# Access Compliance Report

## Public Rights-of-Way

### (Curb Ramps)

Intersection ID: 45497	Main Street: ELIZABETH_CREST_LN	Cross Street: COTTON_PRESS_RD	Location: SW
ADA ID: 4DA65D5CA0B6	Ramp Type: Perp	Initial Pass/Fail: Fail	Overall Compliance: No
Severity Score: 12.5			
Codes/Mitigation Info/Possible Solution		Field Measurements/Component Compliance

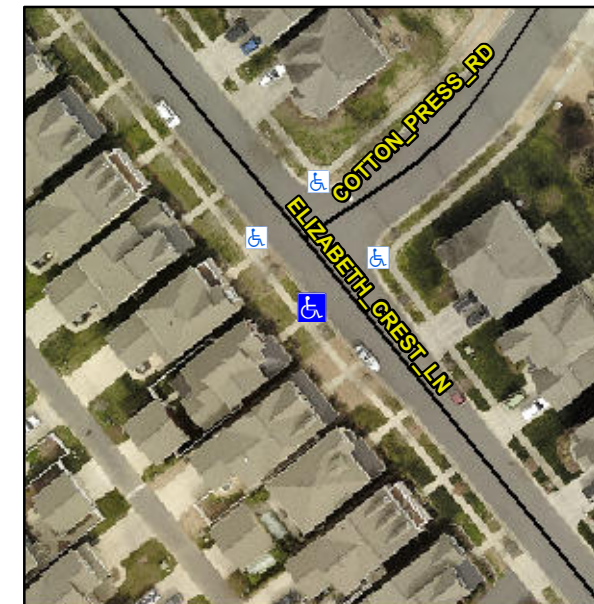
**Not Found, R304.2.2**

Compliance	Description	Data	Compliance	Description	Data
N/A	Ramp Length (in)	71.0	No	Ramp Slope (%)	9.0
Yes	Ramp Width (in)	48.0	Yes	Ramp XSlope (%)	1.6
N/A	Flare Type LT	N/A	N/A	Flare Type RT	N/A
N/A	Flare Slope LT (%)	N/A	N/A	Flare Slope RT (%)	N/A
N/A	Flare Traversable LT?	N/A	N/A	Flare Traversable RT?	N/A
N/A	Landing Length (in)	N/A	N/A	DWS Provided?	N/A
N/A	Landing Width (in)	N/A	N/A	DWS Contrast?	N/A
N/A	Landing Slope (%)	N/A	N/A	DWS Length (in)	N/A
N/A	Landing X Slope (%)	N/A	N/A	DWS Full Width?	N/A
N/A	Landing Curb? (Y/N)	N/A	N/A	DWS Offset (in)	N/A
N/A	Shared Landing?	N/A			
N/A	Gutter Ponding?	N/A	N/A	Gutter Slope (%)	N/A
N/A	Gutter Lip Ht (in)	N/A	N/A	Gutter X Slope (%)	N/A
N/A	Painted X Walk1?	No	N/A	Painted X Walk2?	N/A
	X Walk 1 Direction	To NE		X Walk 2 Direction	N/A
N/A	X Walk 1 Width (in)	N/A	N/A	X Walk 2 Width (in)	N/A
	X Walk 1 Slope (%)	3.0		X Walk 2 Slope (%)	N/A
	X Walk 1 X Slope (%)	10.0		X Walk 2 X Slope (%)	N/A

**Remove & Replace Entire Ramp.**
